**National Highway
Traffic Safety
Administration**

DOT HS 812 590

CAFE Model Peer Review

Figure 2. Engine-Level Paths

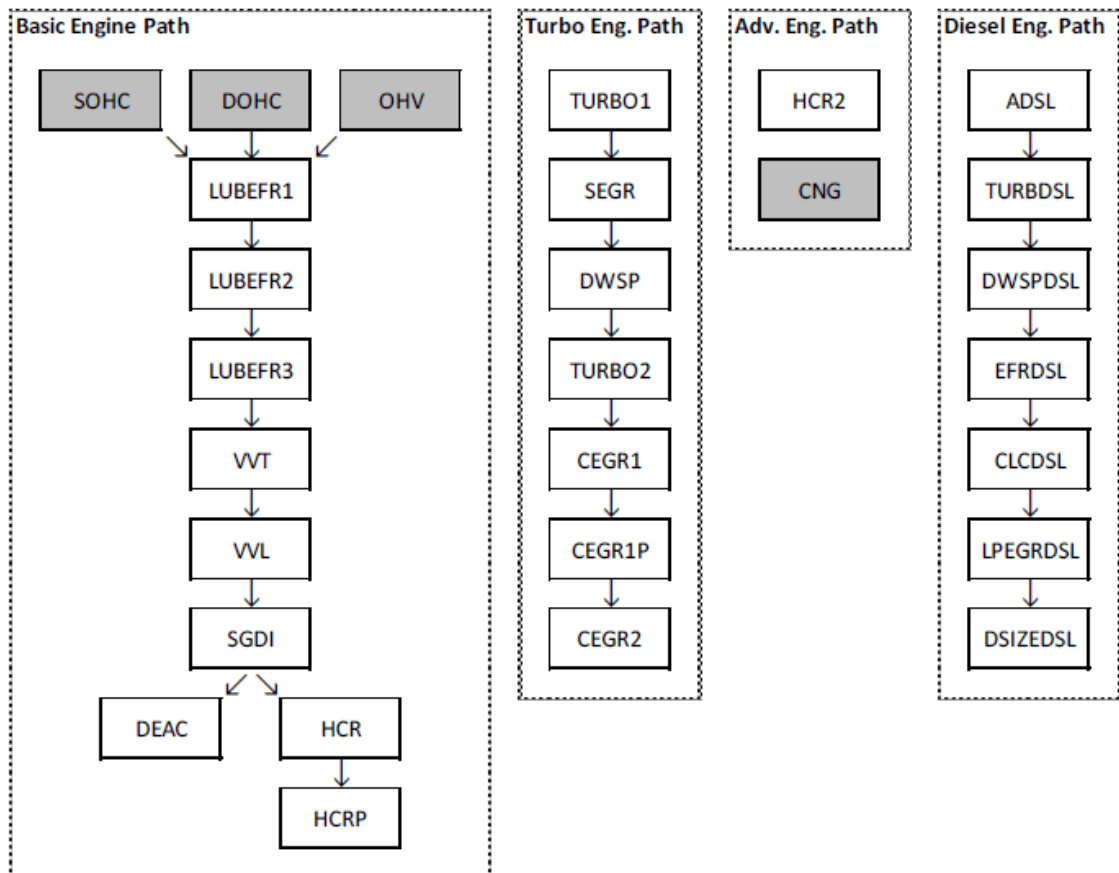
Concern 1:

Revise the Engine Level Paths (Figure 2) and Transmission Level Paths (Figure 3) to include the new engine and transmission technologies and the new transmission terminology introduced in the 2016 Draft TAR.

Figure 3. Transmission-Level Paths

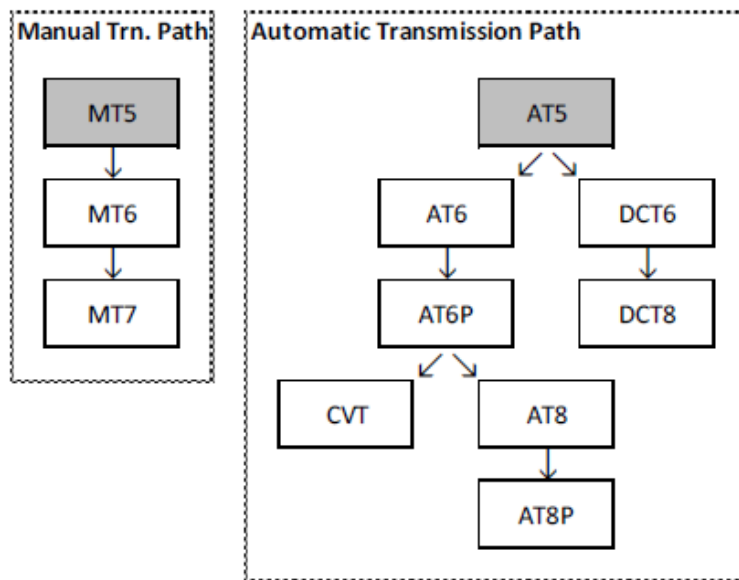
The new transmission terminology, TRX11, TRX12, TRX21, TRX22 is not used in Figure 3. In the "TRX" numbering system the first digit specifies the number of gears in the transmission and the second digit specifies the HEG level (high-efficiency gearbox). A "1" in the first digit represents a 6-speed transmission (as shown in Table 5.78, but incorrectly described as an 8-speed in the text (p. 5-297, line 6)) and a "2" in the first digit represents an 8-speed. Similarly, a "1" in the second digit represents HEG1 and a "2" in the second digit represents HEG2. (2016 Draft TAR, p.5-297)

Figure 3 shows that the DCT path ends at DCT8 without being able to return to the AT or CVT path. However, some current DCT applications are likely to revert to an AT8 or a CVT with a future redesign, to resolve drivability issues with the DCT, particularly those using dry clutches.

Revise the Transmission Level Paths (Figure 3) to show that a DCT path, at any point, could revert to the AT or CVT path.

RESPONSE: The transmission path reflects an assumption that, having made investments to—presumably successfully—replace a given AT with a DCT, the manufacturer would be most likely to continue with the DCT technology rather than reverting to an AT. Model inputs could be adjusted to force the model to simulate other assumptions (e.g., by setting the model to “skip” DCT options for specific transmissions).

Figure 4. Platform-Level Paths

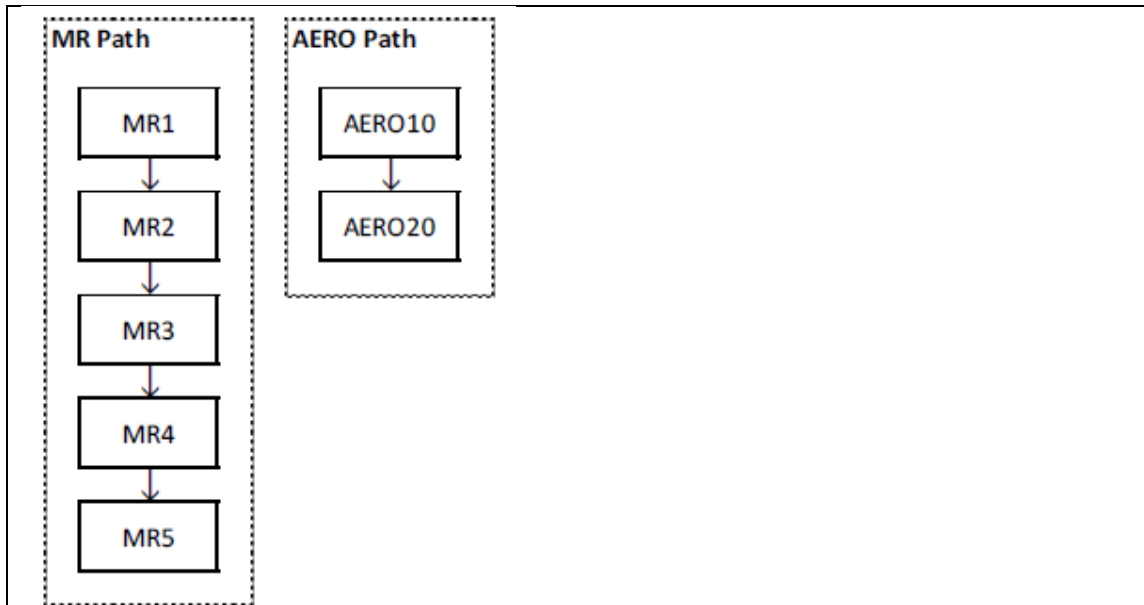
Provide an explanation of how the baseline MR and AERO levels, described in Tables 4.49 and 4.50 for mass reduction and Table 4.56 for aerodynamic drag reductions, are incorporated in the Volpe Model after the discussion of Figure 4. (The MR Levels and AERO Levels of the baseline vehicles are required input to Table 9, Vehicles Worksheet). Define where/how the mass reduction cost curves are entered for the variety of different baseline MR levels shown in Table 4.49.

Figure 6. Technology Pathways Diagram

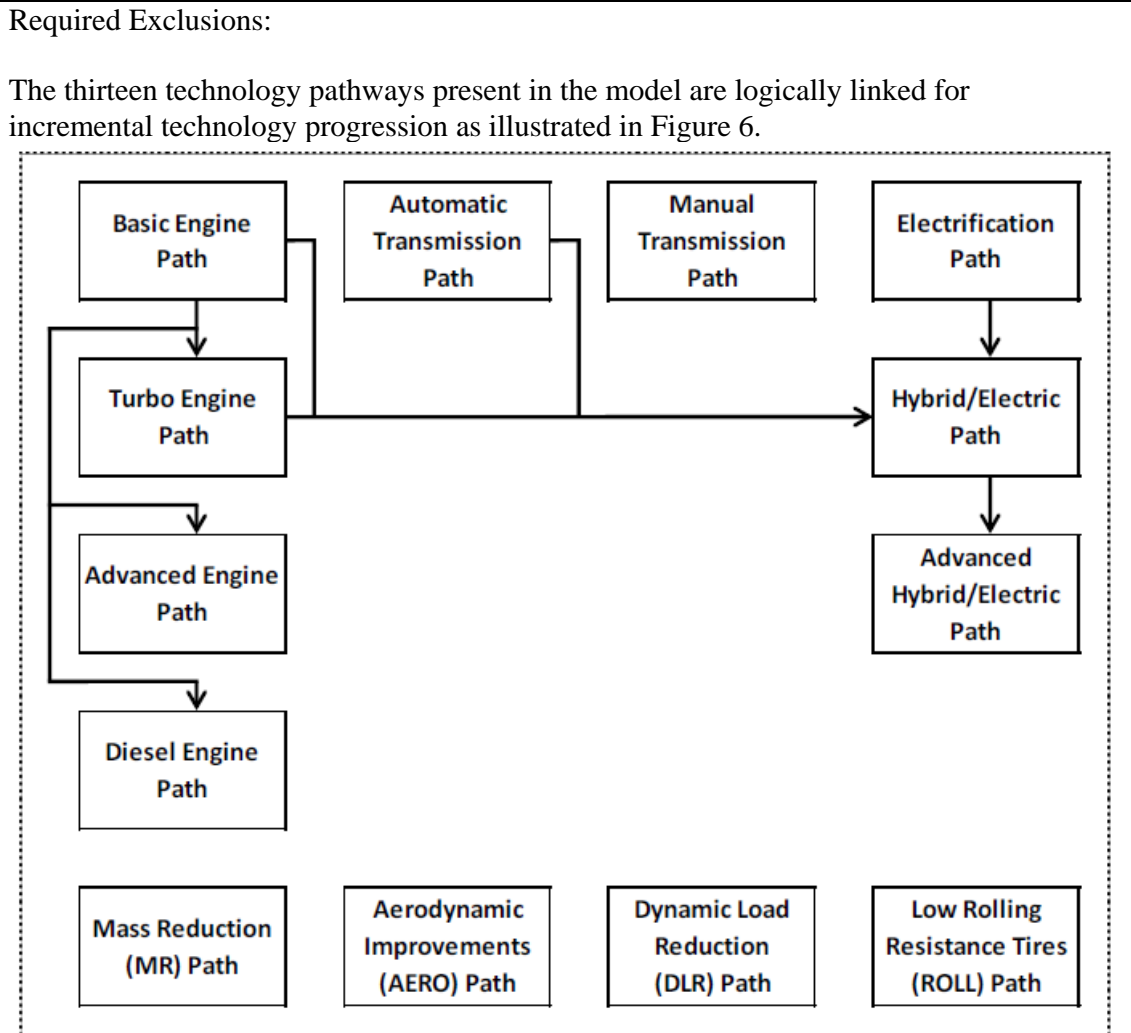
Some of the technology pathways, as defined in the CAFE Model and shown in Figure 6, may not be compatible with a vehicle given its state at the time of evaluation. For example, a vehicle with a 6-speed automatic transmission will not be able to get improvements from a Manual Transmission path. Therefore, the system explicitly disables certain paths whenever a constraining technology from another path is applied on a vehicle.
